ADDENDUM

PROJECT NAME: Our Lady of Perpetual Help – Barrier Free Elevator Expansion

ADDENDUM NO.: PTA-E-01

1.1 Drawings E001, E002, E003, E004, E100, ED100 (Attached)

Title :
POWER, LIGHTING AND SYSTEMS PLAN

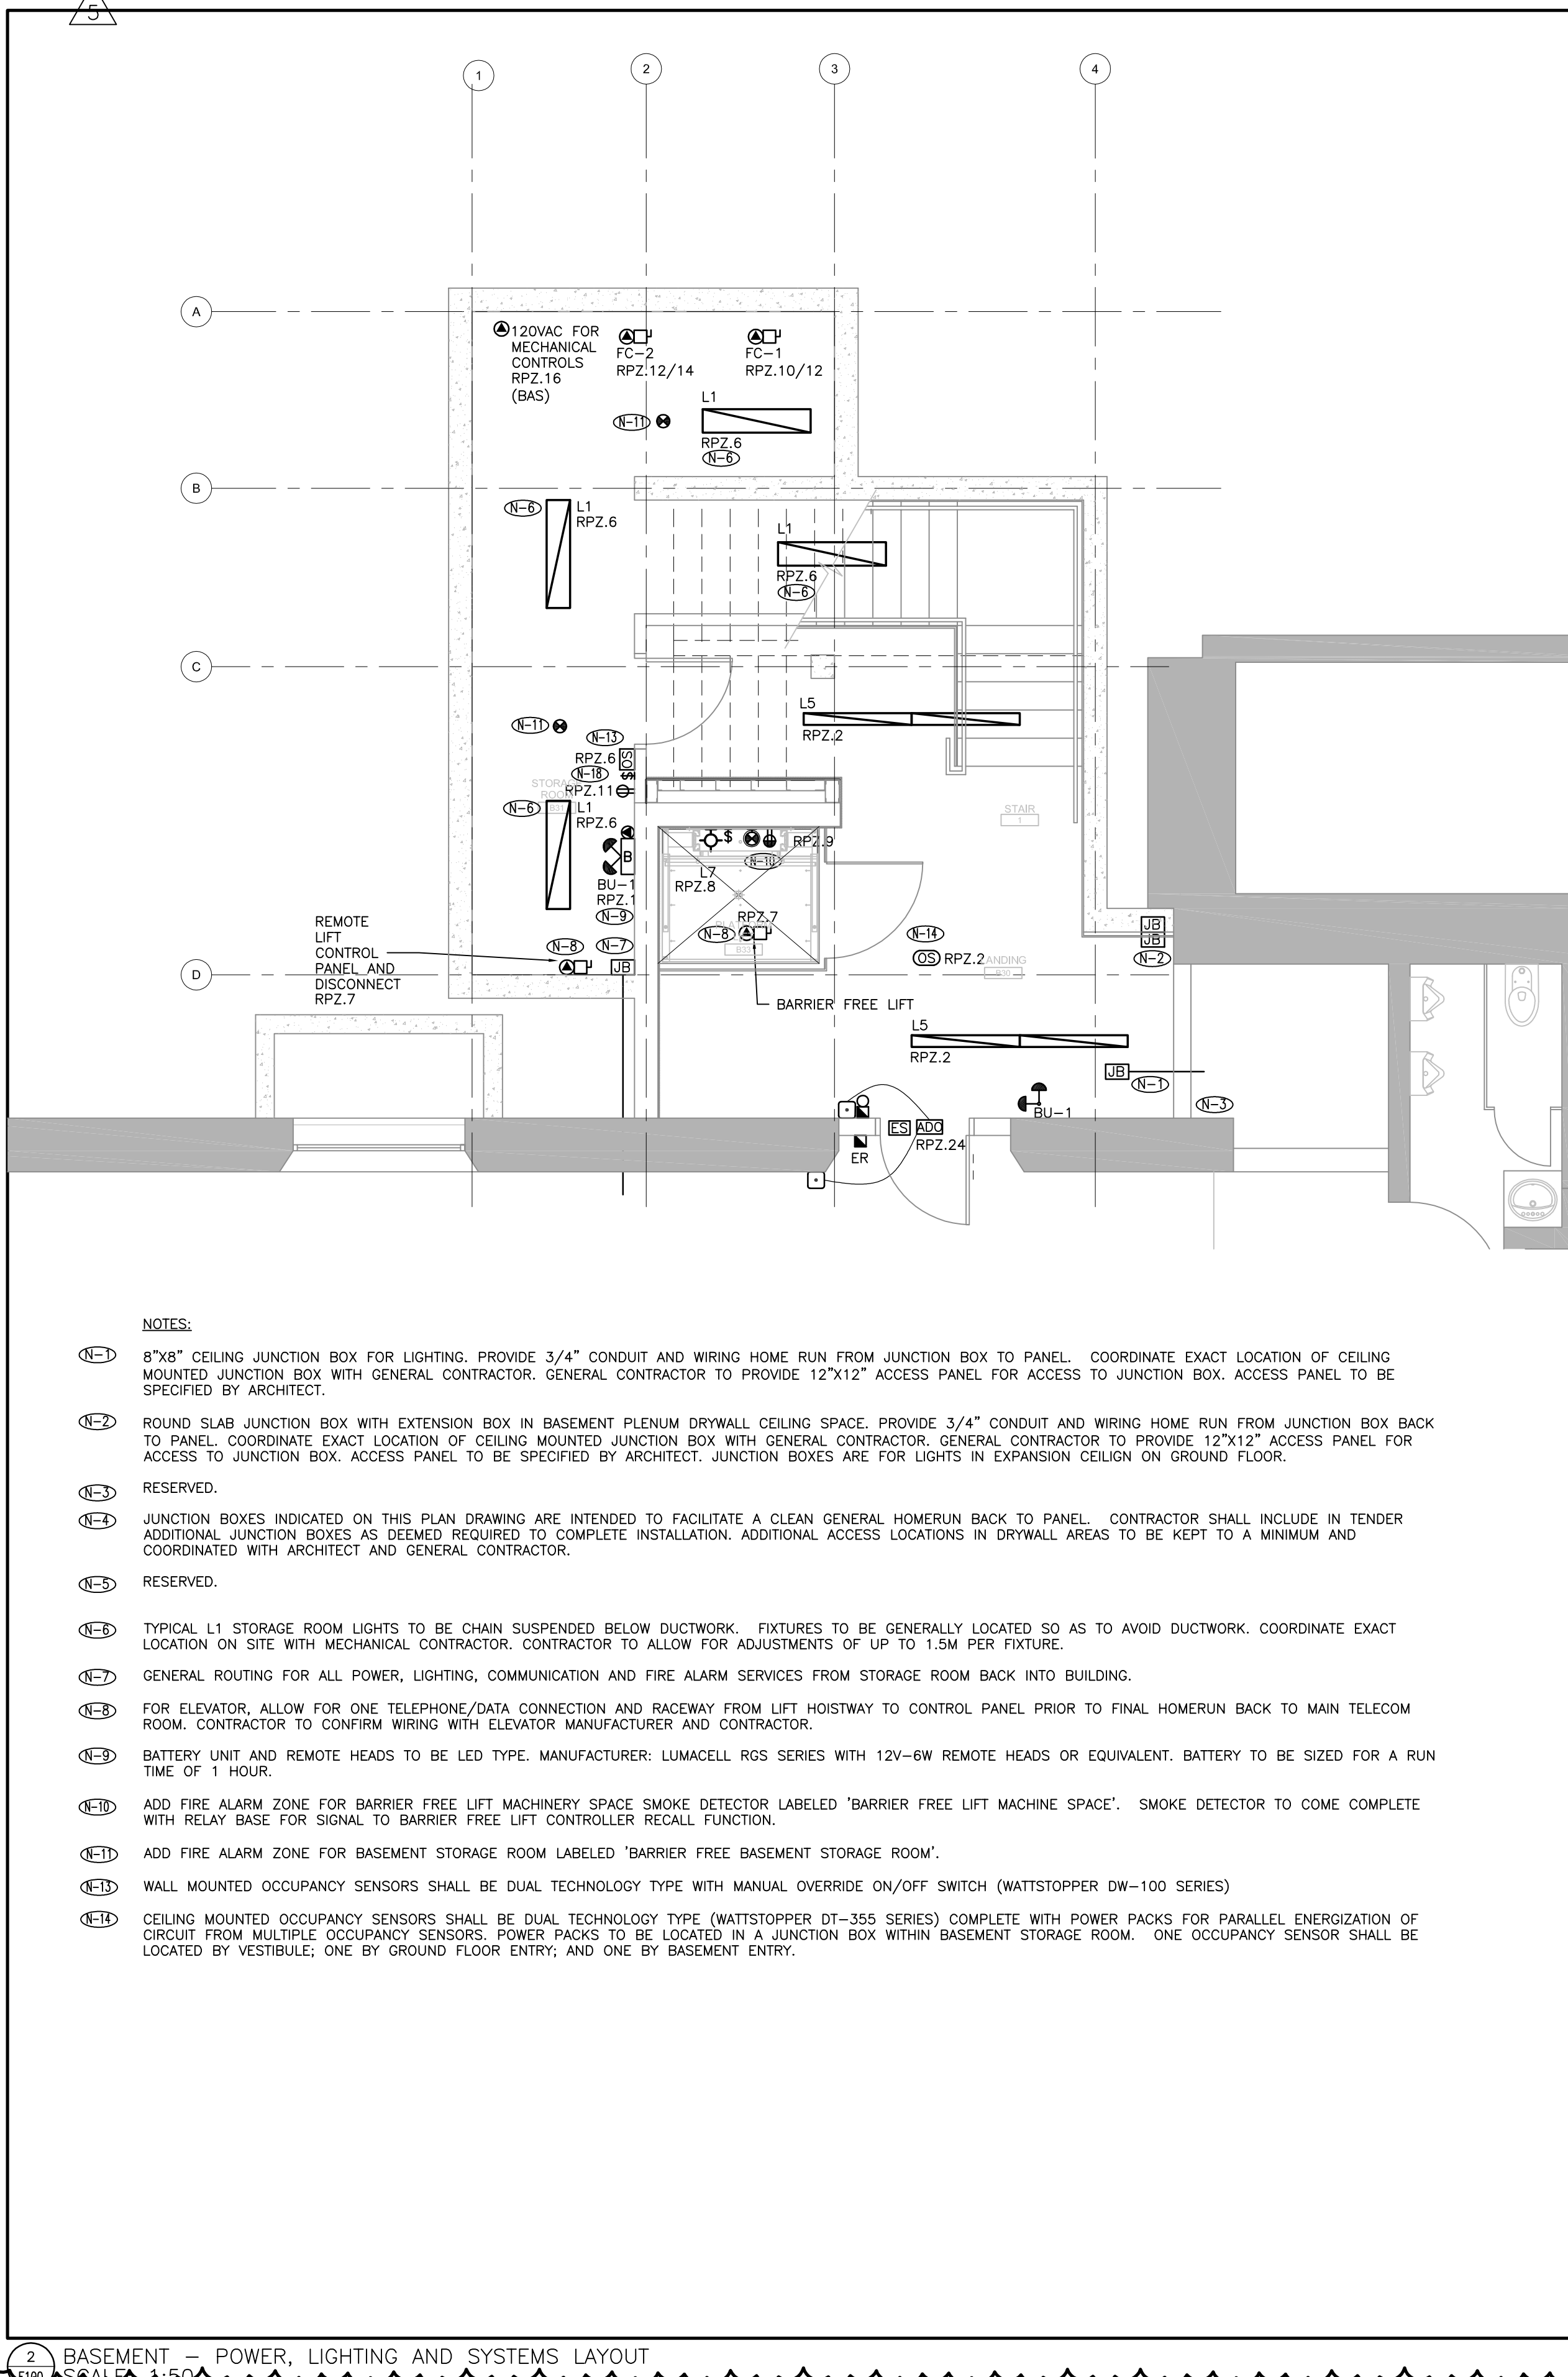
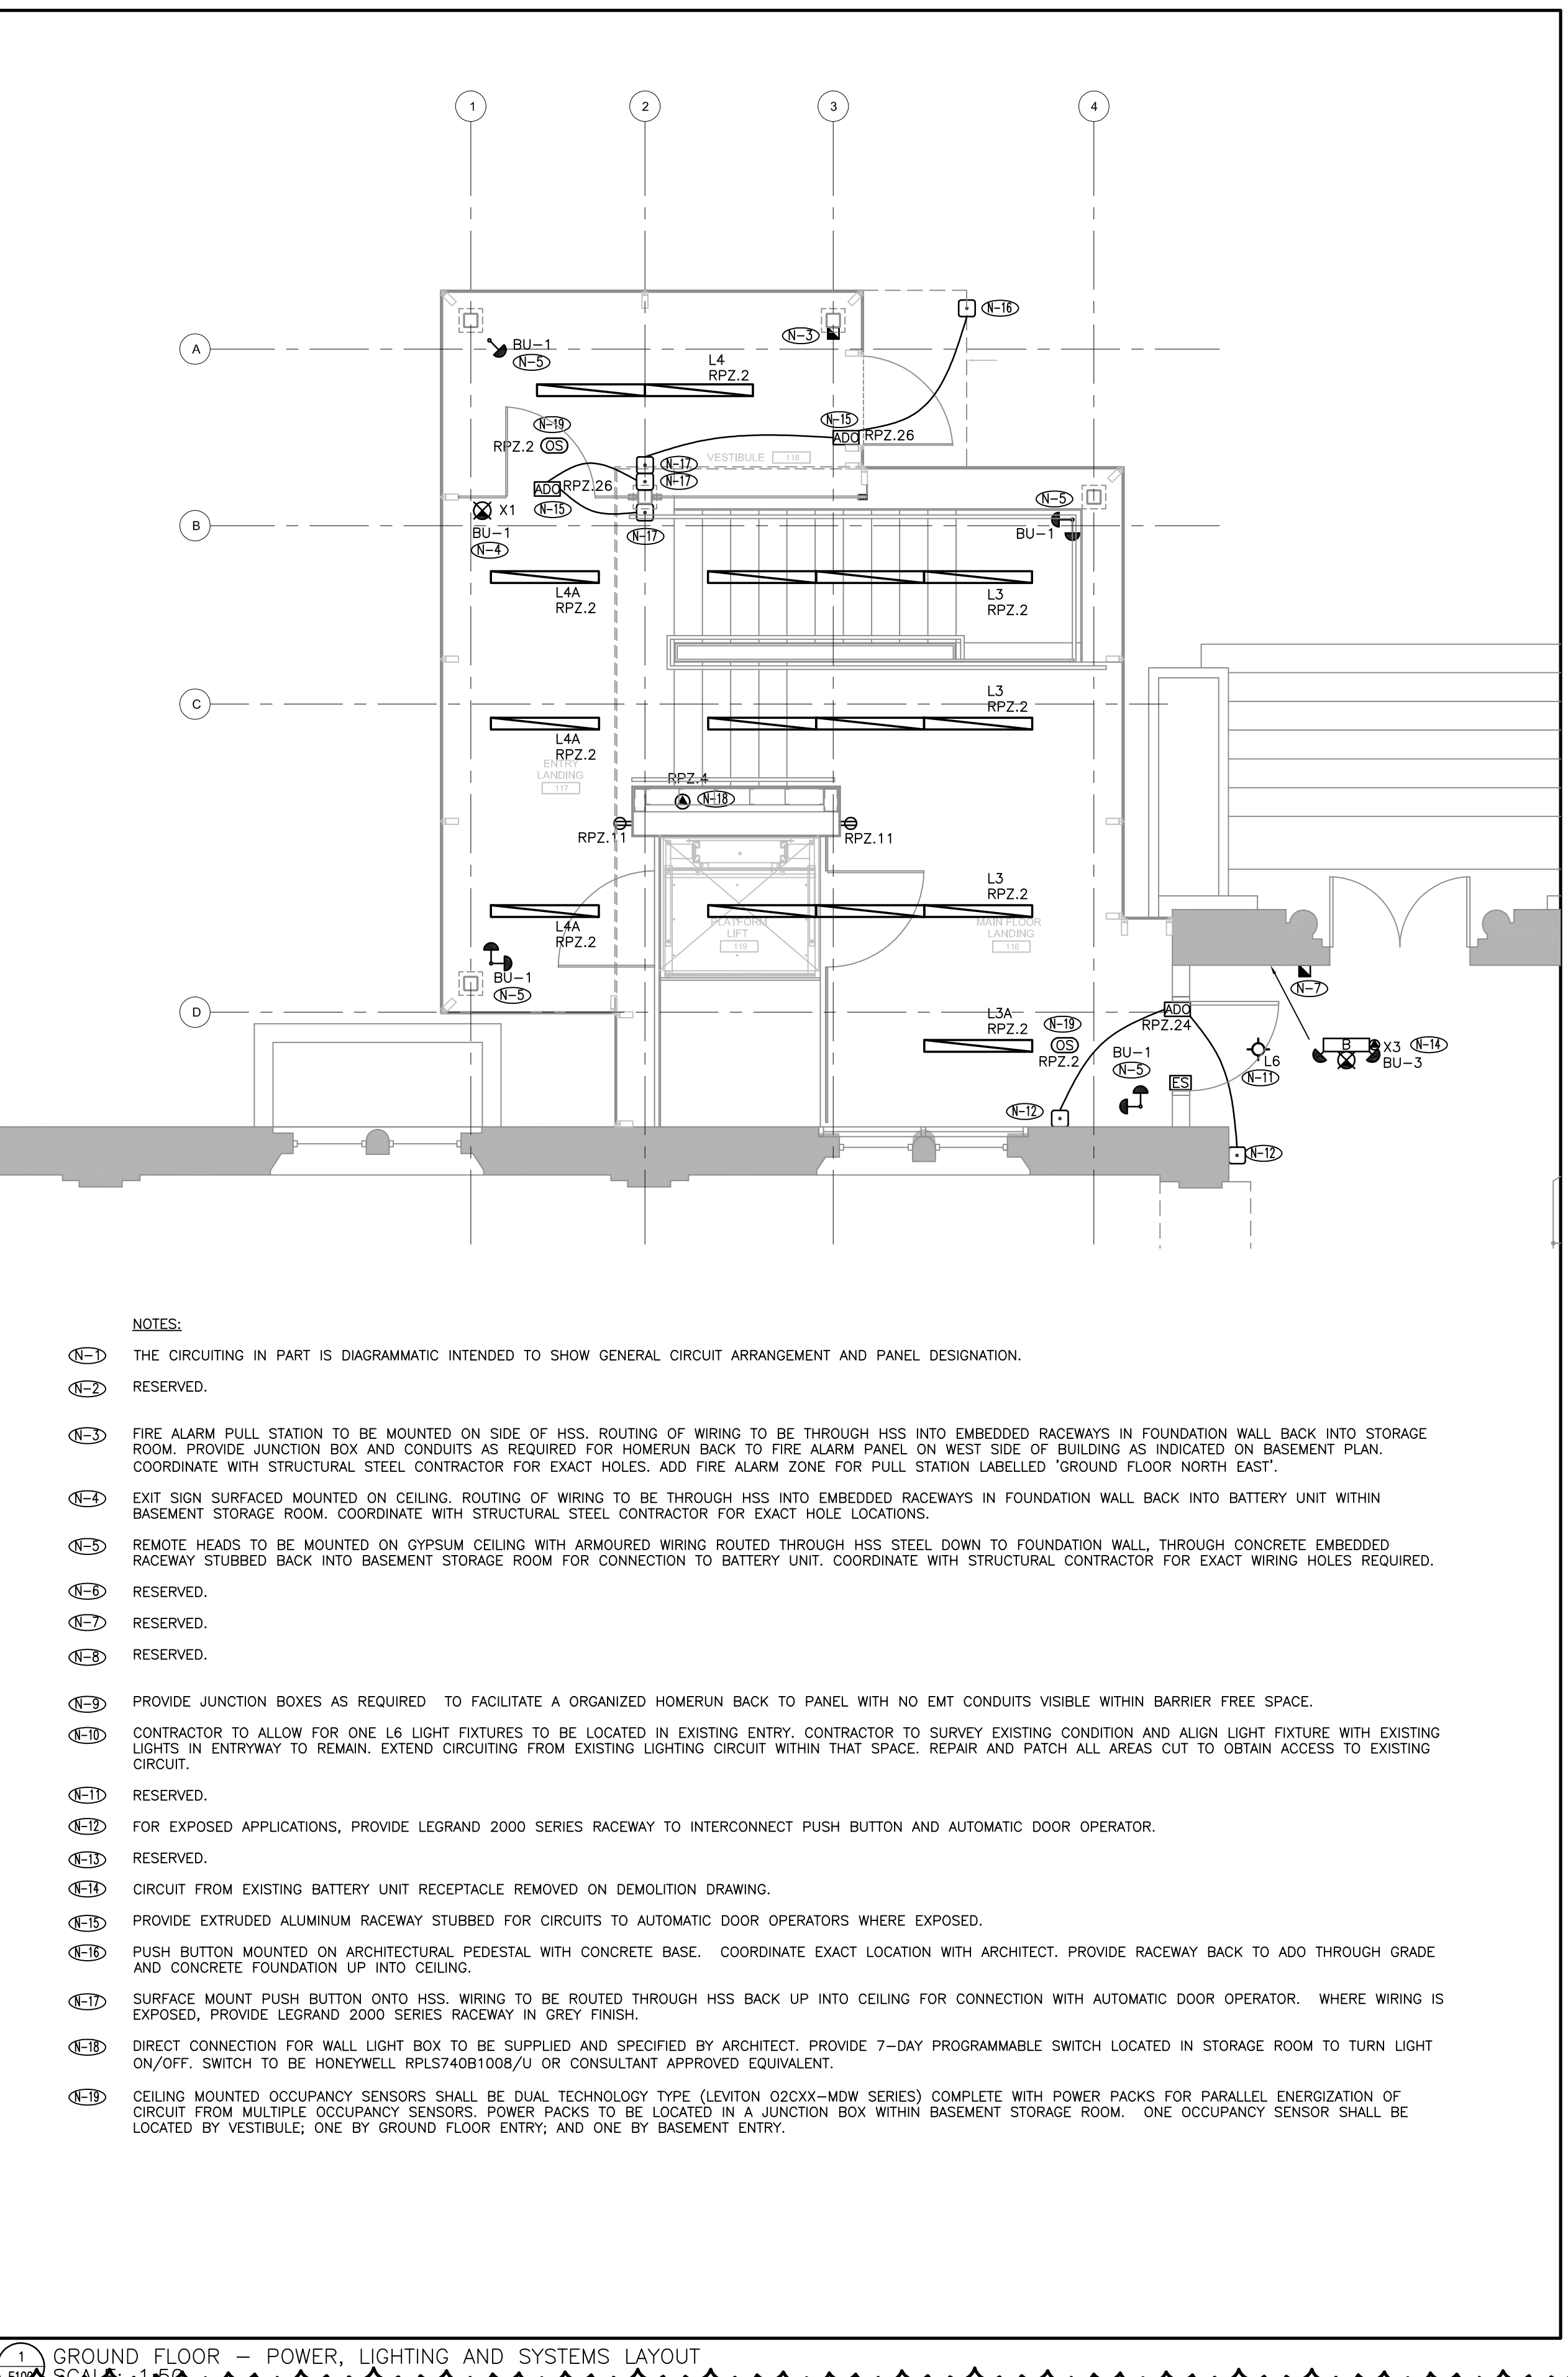
2.4 E100

2.4.1 Revise lighting layout as shown. Ceiling of expansion has been revised to drywall ceiling aligned with structural HSS. Summary of revisions described as follows:

- .1 Delete bollard lighting and step lighting.
- .2 Replace bollard lighting and step lighting with ceiling mounted suspended or surface mounted linear led fixtures as shown.
- .3 Revise basement ceiling recessed lighting to match ground level manufacturer as shown.

- .4 Revise occupancy sensor location and type as shown. Three occupancy sensors shall control circuit RPZ.2. Occupancy sensor shall be revised to dual tech with photocell as shown by Leviton O2CXX-MDW series or approved equivalent..
- .5 Revise battery unit locations.
- .6 Revise exit sign location from HSS to be ceiling mounted as shown.
- .7 Revise automatic door operator push buttons as shown.
- .8 Generally wiring shall be routed within ceiling of expansion, through HSS as required and down into basement level in storage room. Coordinate holes as required with structural steel contractor.
- .9 Provide Legrand 2000 series raceway in grey finish for all wiring exposed.
- .10 Add 7-day programmable timer light switch for architectural light box provisions.
- .11 Adjust basement storage lighting as shown.
